**GEOTECHNICAL INSPECTION
OF
OPERATIONAL LANDFILL**

November 10, 2003

**Subject: Landfill Cover 2003
Polaris, Nunavut**

Figure 4
Cross-Section A-A Showing
Proposed Redistribution of Material and Final Cover

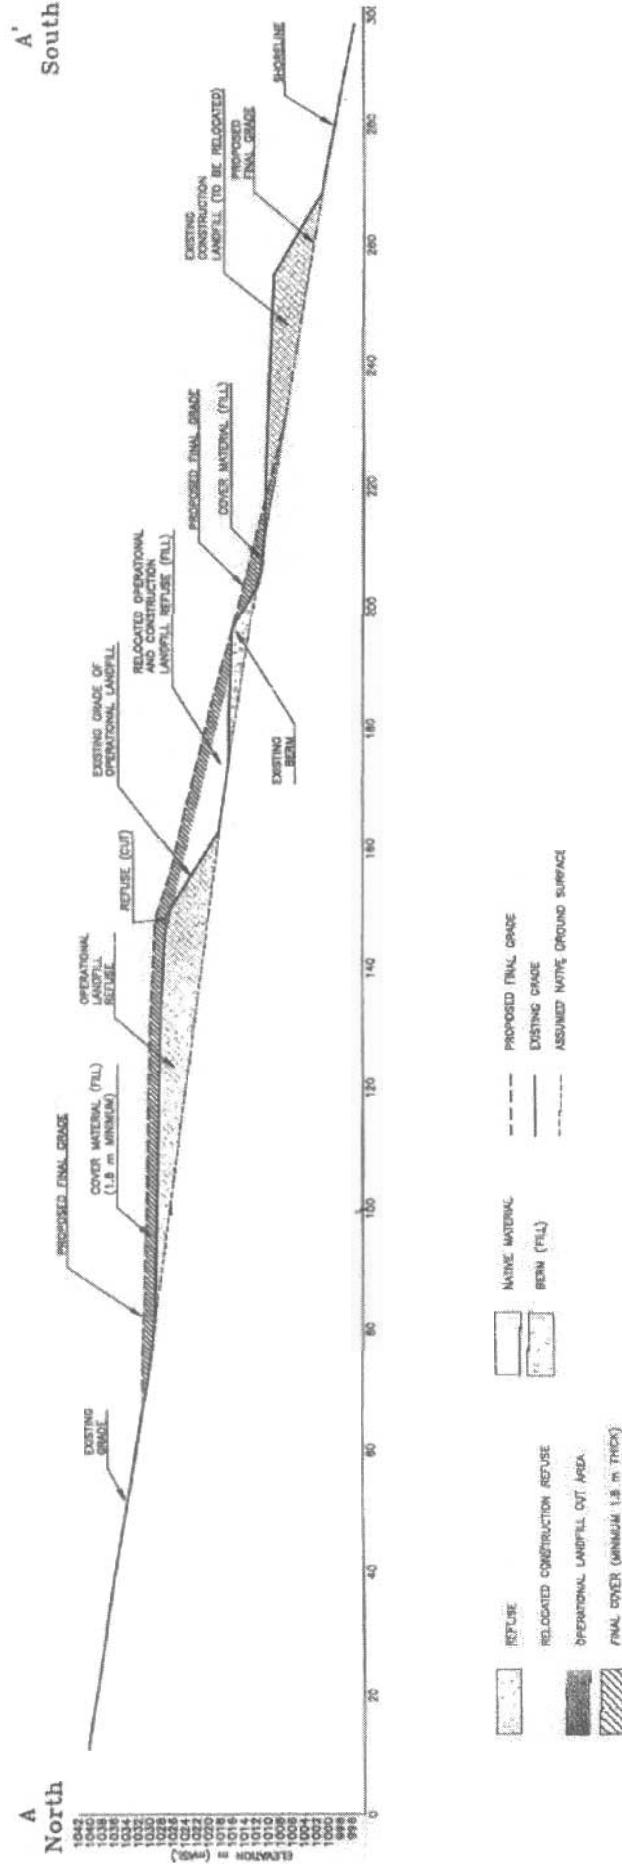
Plan and cross-sectional views of the before and after Operational Landfill configurations are shown in Figures 2 through 6. A typical design section prescribed by GLL is provided in Figure 4. A contour plan and a typical as-built section up to the time of EBA's site visit in August 2003 are provided in Figures 5 and 6, respectively. Photographs of the in-progress landfill on August 19 and 20, 2003 are provided in Appendix C.

Figure 6
Draft Cross-Section A-A showing As-Built (in progress)
Operational Landfill on August 2003 and before Final Placement of
600 mm Thick Cap of Limestone Cover Material Scheduled for 2004

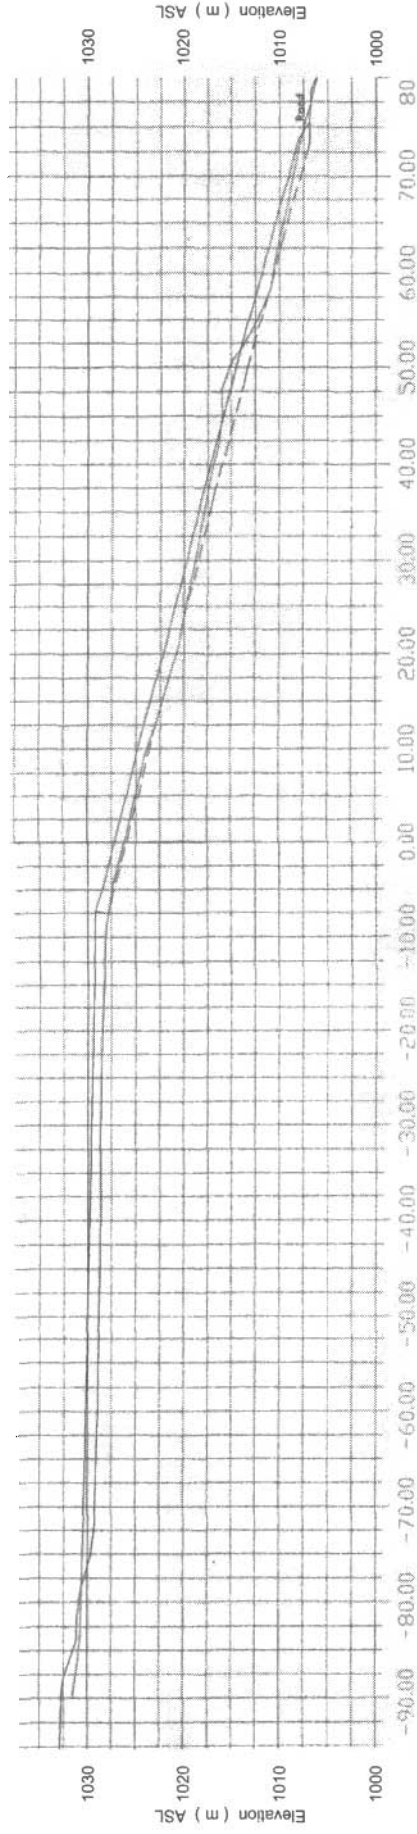
Redistribution of materials at the Operational Landfill was carried out under the direction of TC and surveyed by SNC Lavalin. TC forwarded draft copies of the plotted survey information to EBA. The survey information was prepared for TC by SNC Lavalin and showed the topography before and after placement of the initial lift of capping material. The draft profiles show general compliance with the GLL design grades. Based on the draft information provided the operational landfill is in fact close to the final design elevations and therefore the finished landfill cap elevation after placement of the 0.6 m of limestone in 2004 will be up to 0.6 m higher than the design grades specified.

TC have indicated that final surveyed profiles confirming the cap thickness of 1200 mm will be provided in subsequent reviews.

Plotted August 18th Results of Sieve Analysis by TC for 200 mm minus Material- Only 80 mm minus portion plotted

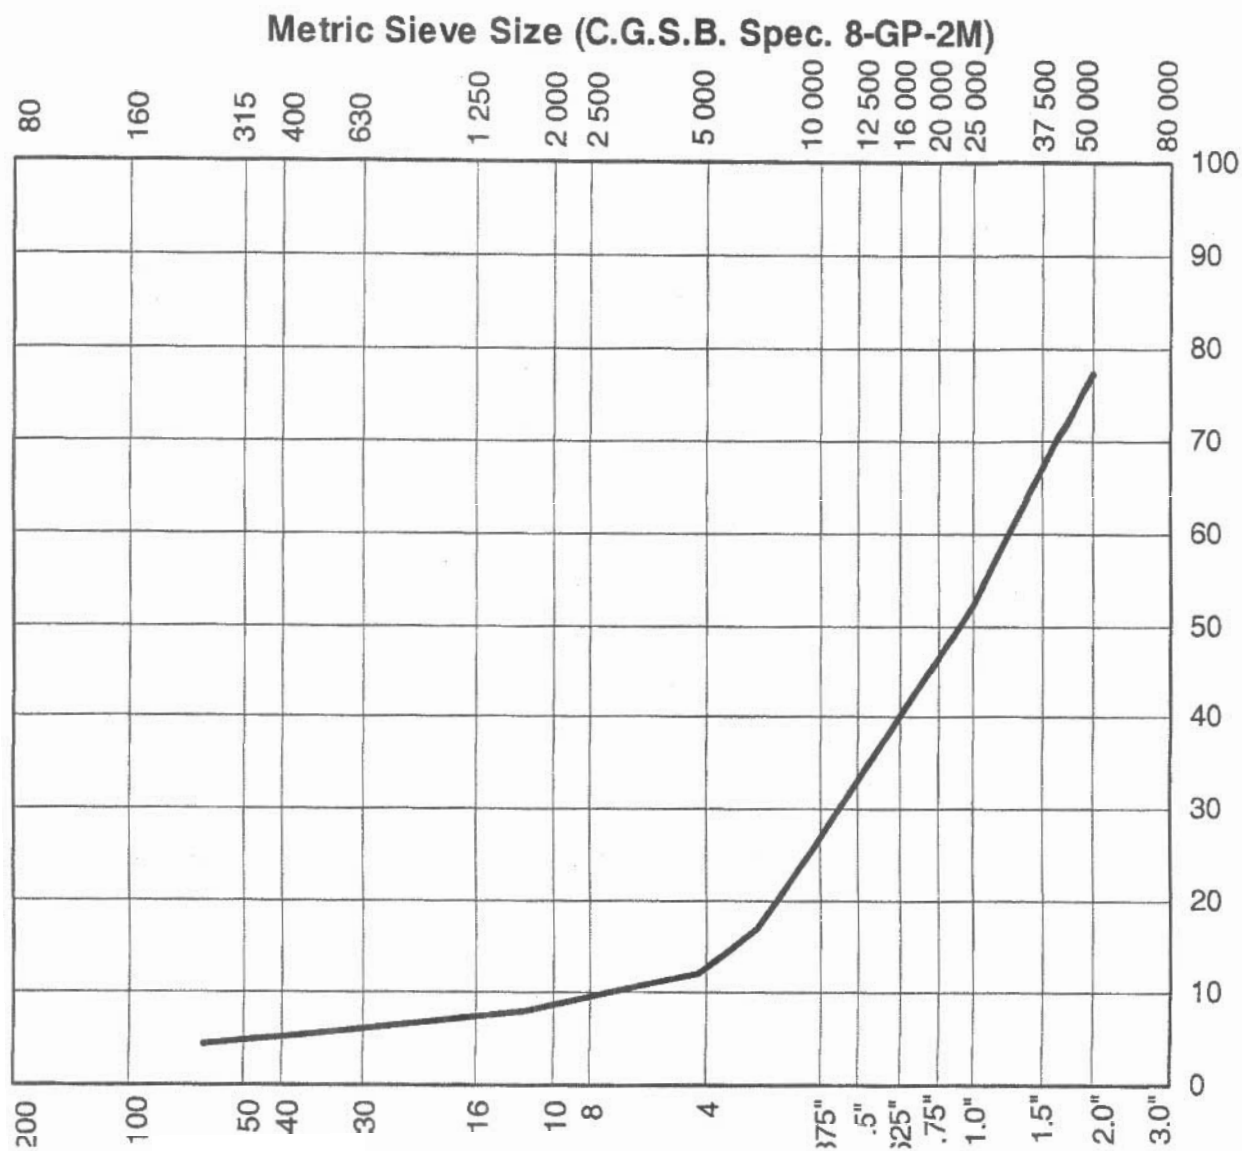
The results of two gradation analyses carried out by TC were provided to EBA (dated July 28 and August 18). Results of the gradation analyses are shown in Appendix B. Testing frequencies by TC are below that specified by GLL, however, the materials tested comply with the GLL gradation specification. TC reported that two or three other samples taken during cap placement remain to be tested.

In general the shale fill appears clast supported, however, the fractions of sand and silt vary somewhat. Some areas showed substantial segregation at finished grade comprising entirely of gravel to cobble size angular materials that are very pervious (Photo 1). In other areas the matrix material is sand with some silt.

Moisture content measured on the July 28 shale sample was 4.9 percent.
